CITY OF SUPERIOR, WISCONSIN
 DEPARTMENT OF PUBLIC WORKS

CONTRACT NO. 3
 LIFT STATION 5 AND STORAGE PLAN

CONTRACT NO. 3
LIFT STATION & STORAGE IMPROVEMENTS

LIFT STATION & STORAGE IMPROVEMENTS

PROJECT	LIFT STATION # STORAGE IMPROV.
LOCATION	SUPERIOR, WI
ARCHT/ENG	BETA ENGINEERING, INC.
CUSTOMER	REUBEN JOHNSON & SONS
TITLE	LIFT STATION No. 5 PARTIAL WALL REINF.

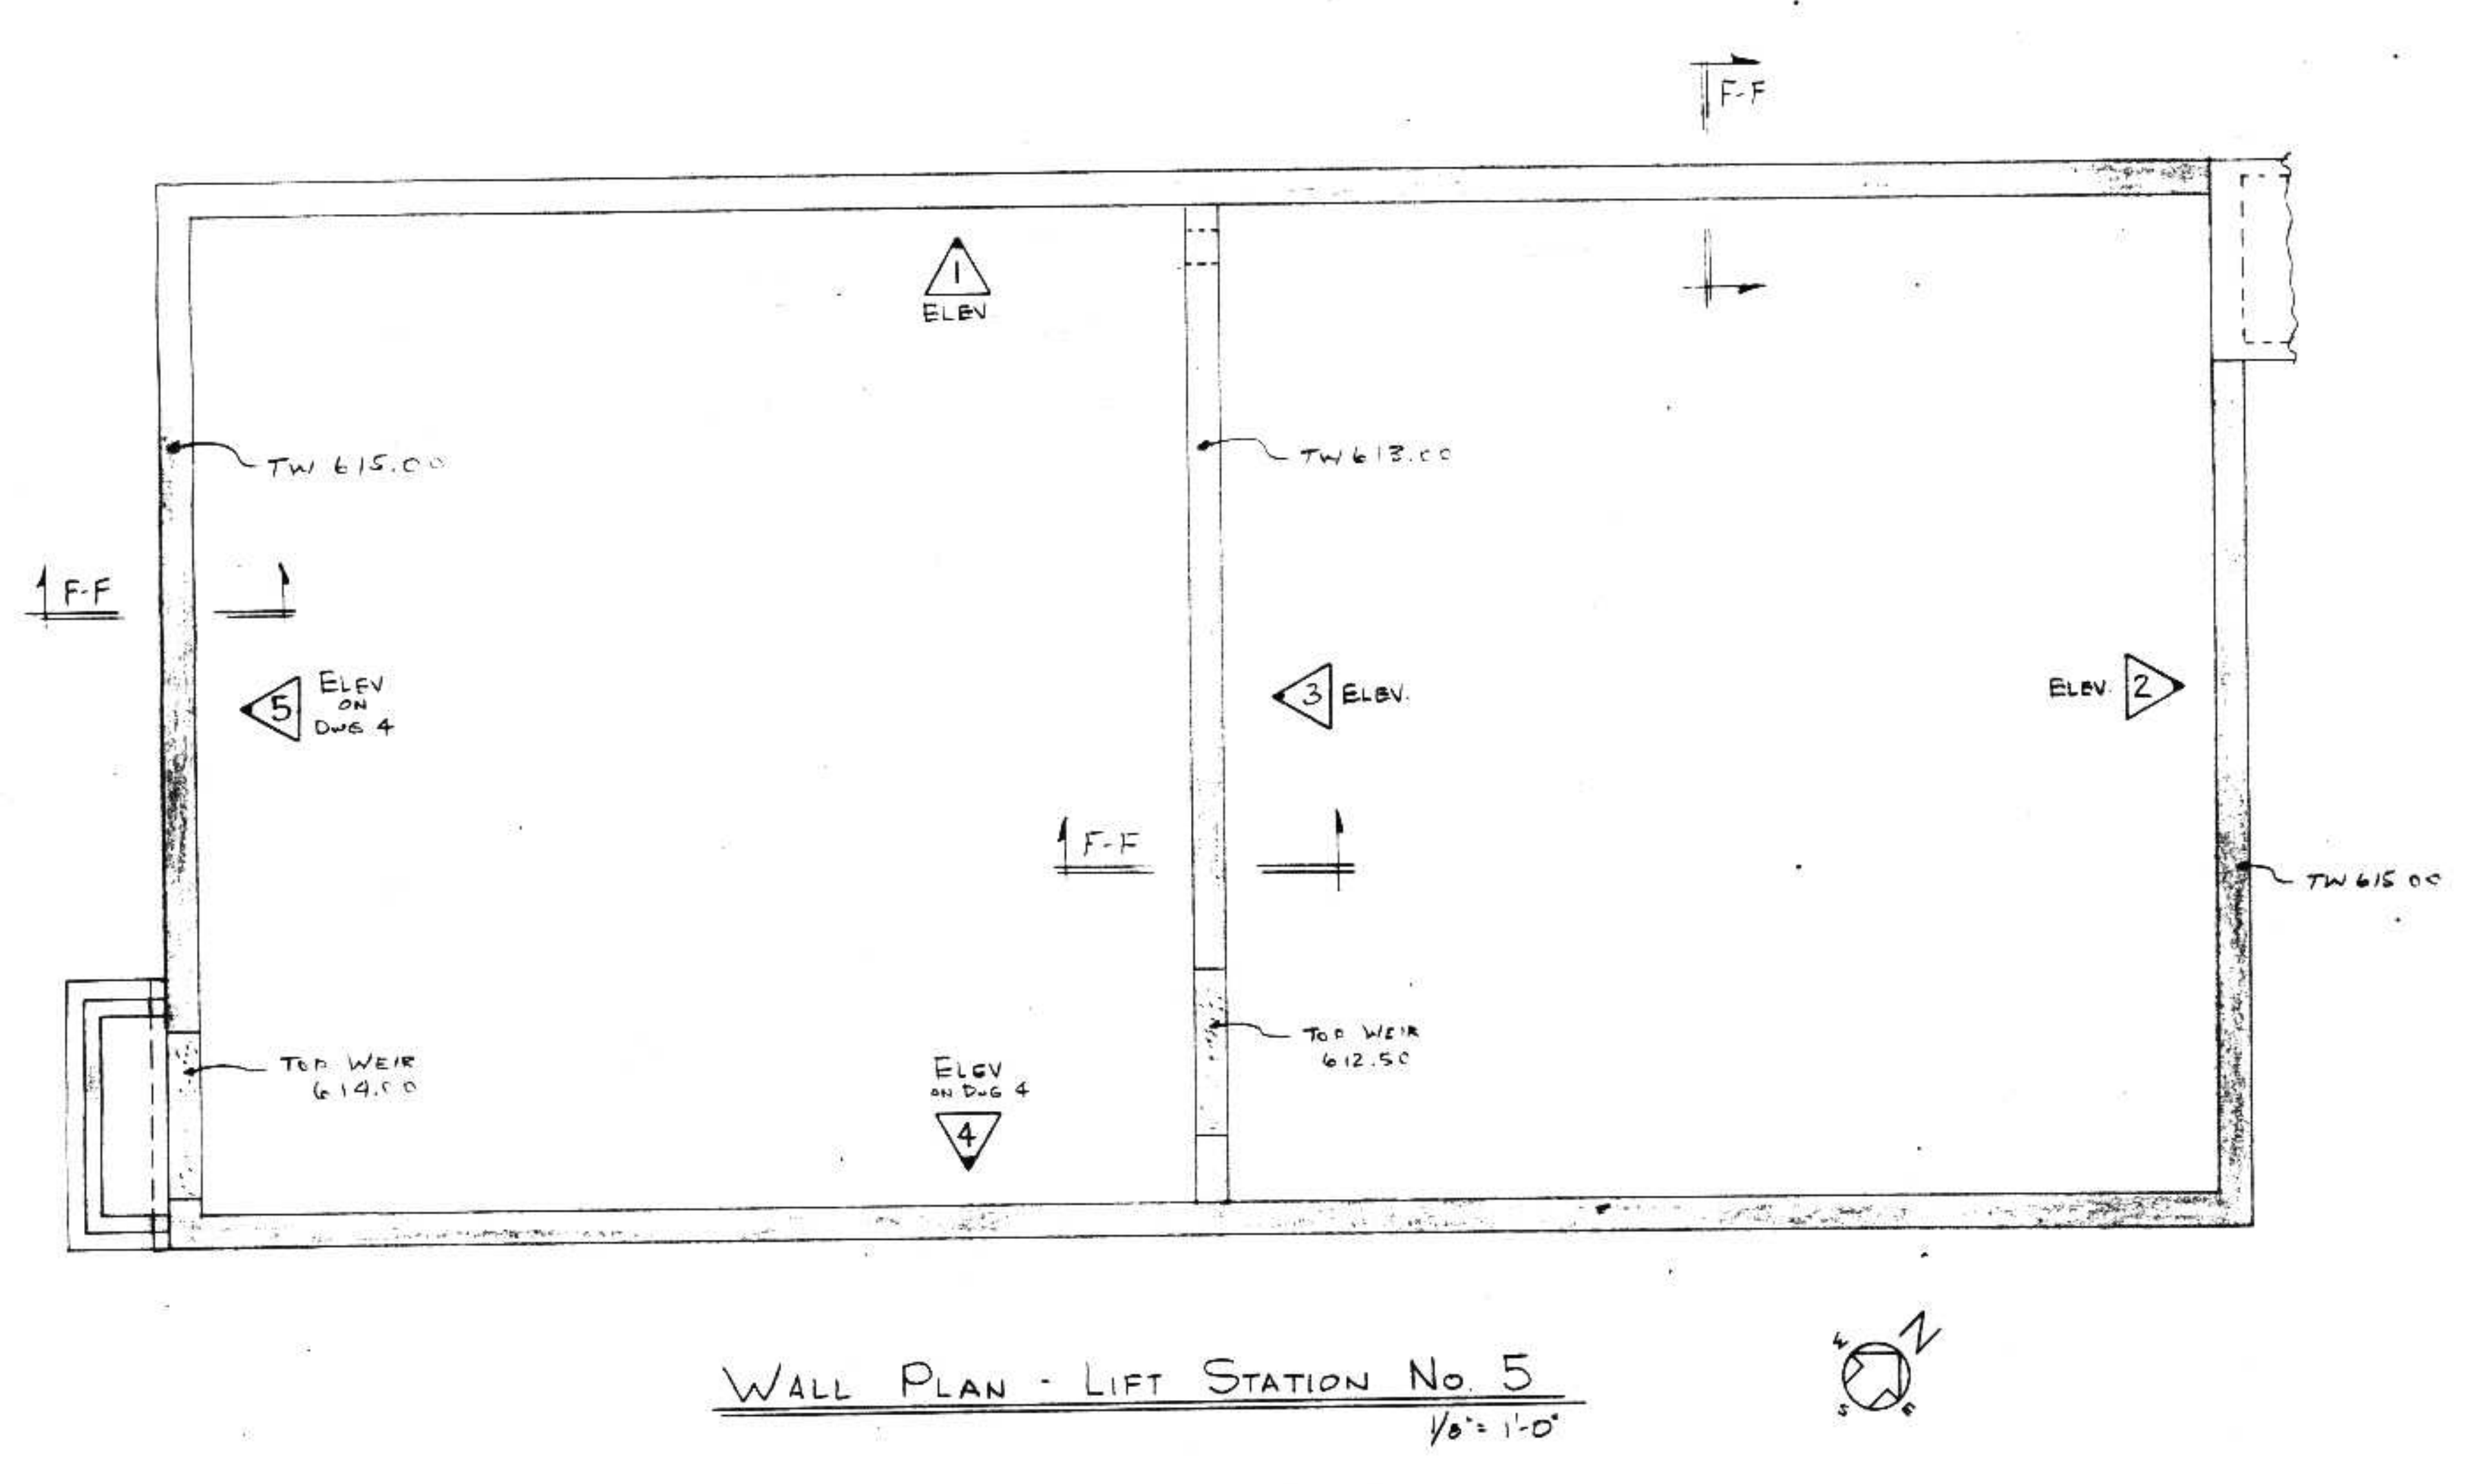
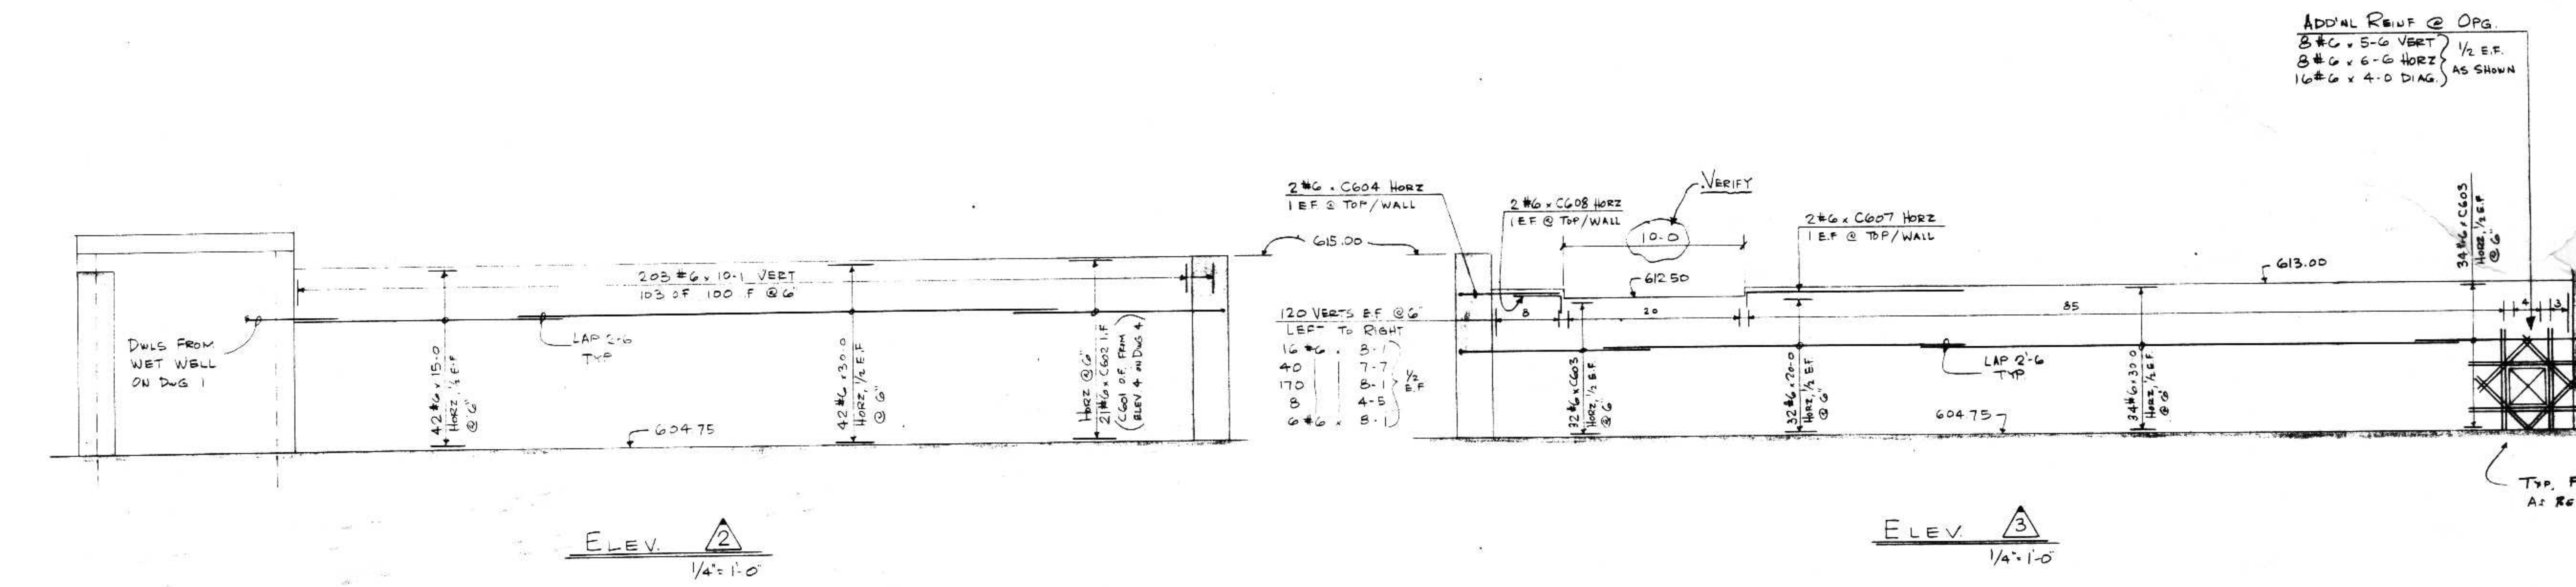
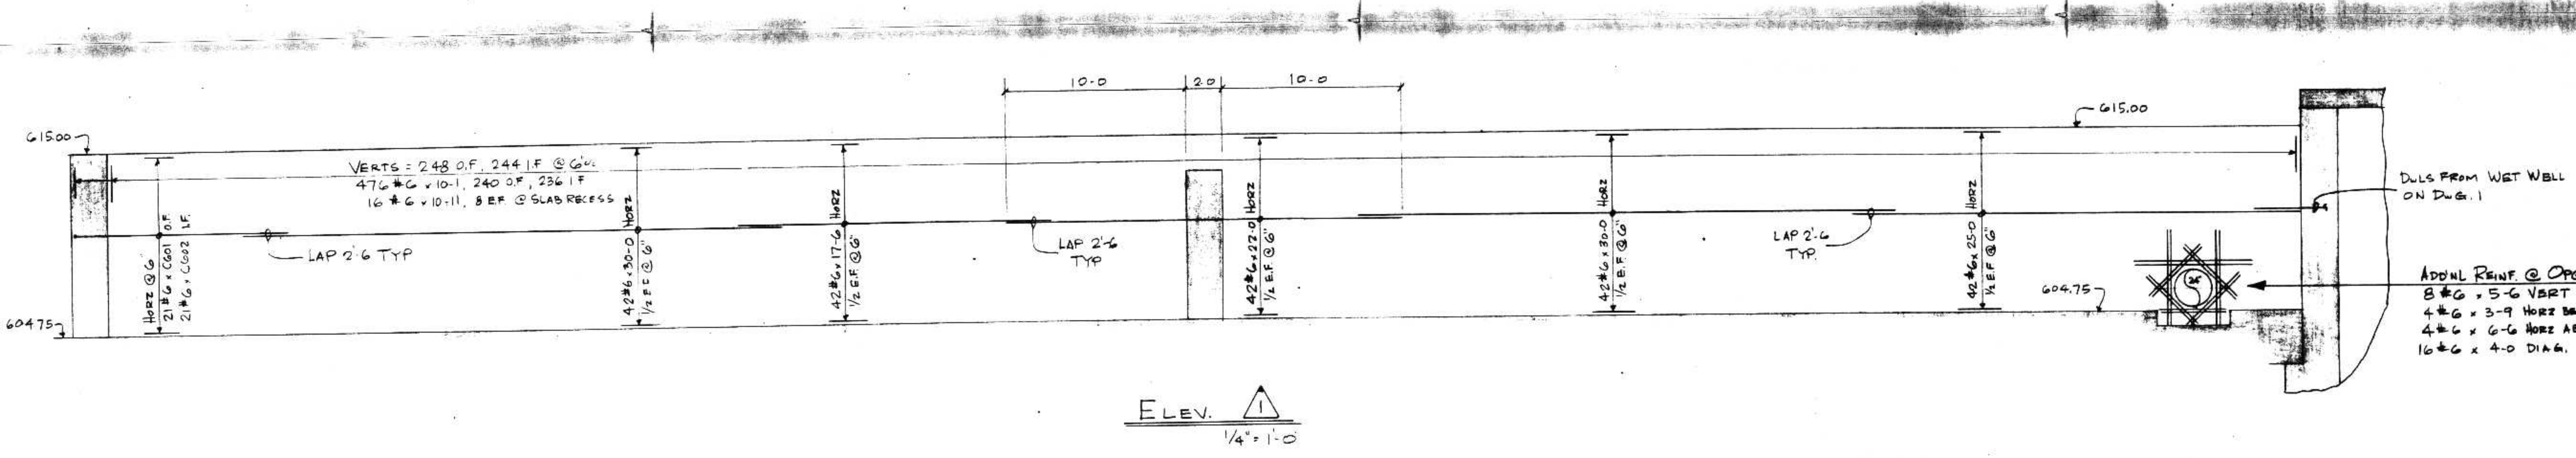
Will joints?
